CDM: Recommendation Form for Small Scale Methodologies (version 01)
(To be used for presenting questions/proposals/amendments to the simplified methodologies for small-scale CDM project activity categories)

Date of SSC WG meeting:	09–12 May 2011, SSC WG 31
Title/Subject (give a small title or specify the subject of your submission, maximum 200 characters):	Revision of AMS-I.C to include additional baseline scenario for a new cogeneration project.
Indicative methodology to which your submission relates (refer the items of Appendix B of the Simplified Modalities and Procedures), if applicable.	AMS-I.C “Thermal energy production with or without electricity”
Name of the authors of the query:	Kishor Rathod Institution: ecolutions Carbon India Pvt.Ltd. kishor.rathod@ecolutions.de , jayshri.jamliya@ecolutions.de

Diagrammatic representation of pre-project scenario-

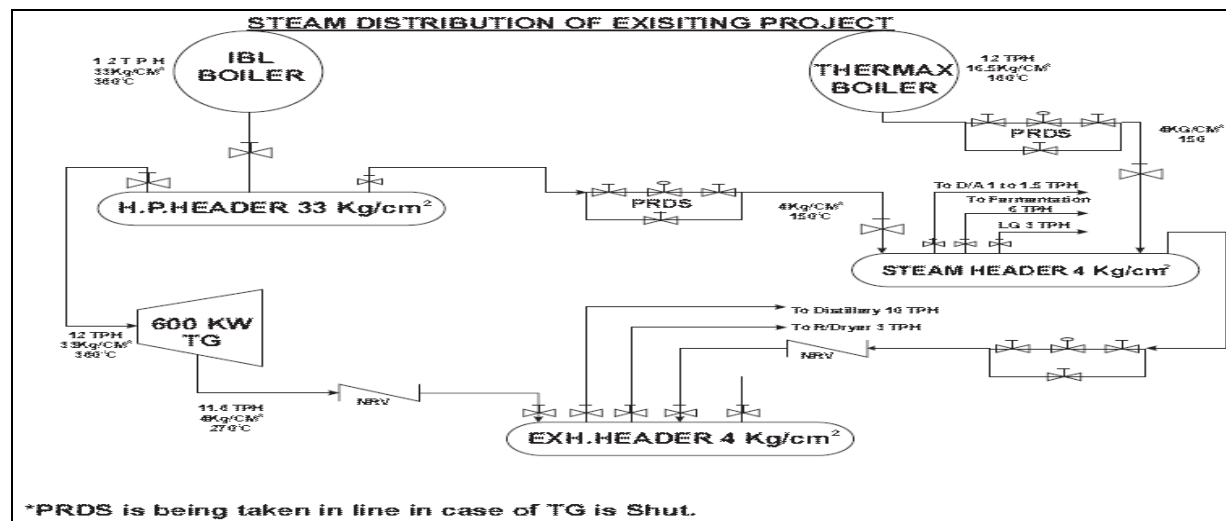
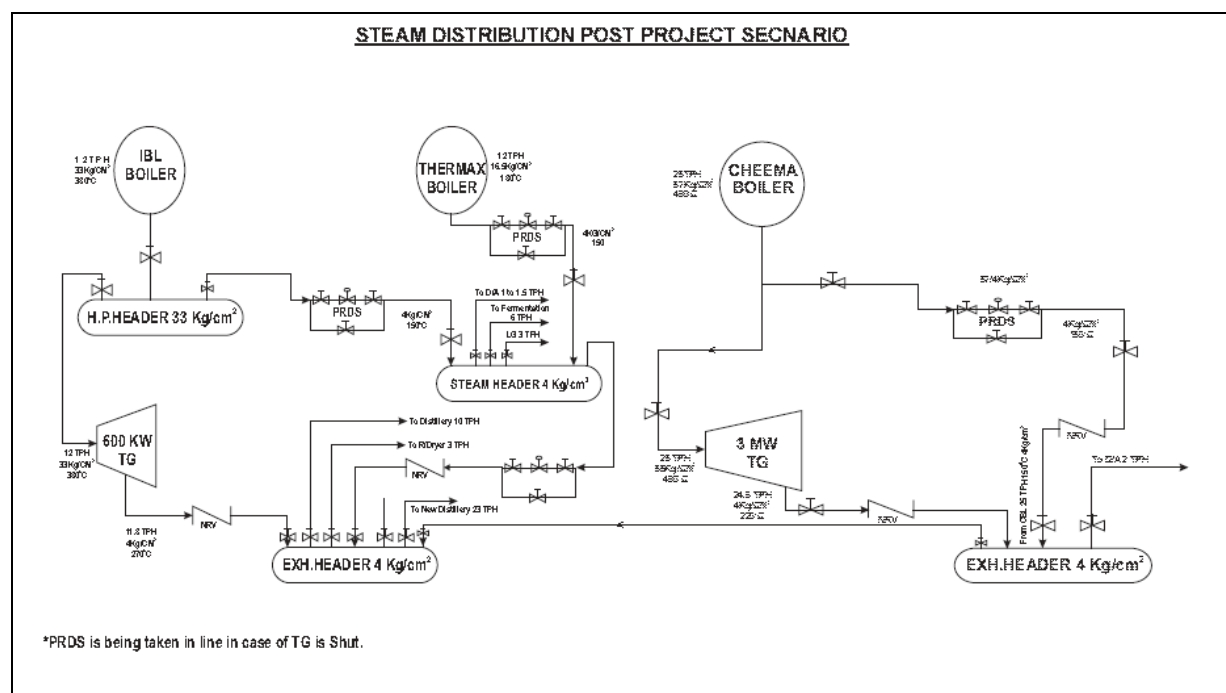
The manufacturing facility's thermal requirement is being met by biomass based boiler (2*12 TPH). The electricity demand is being met by the supply from the Grid & 600 KW biomass based captive cogeneration power plant or DG set (In case of PSEB power cuts).
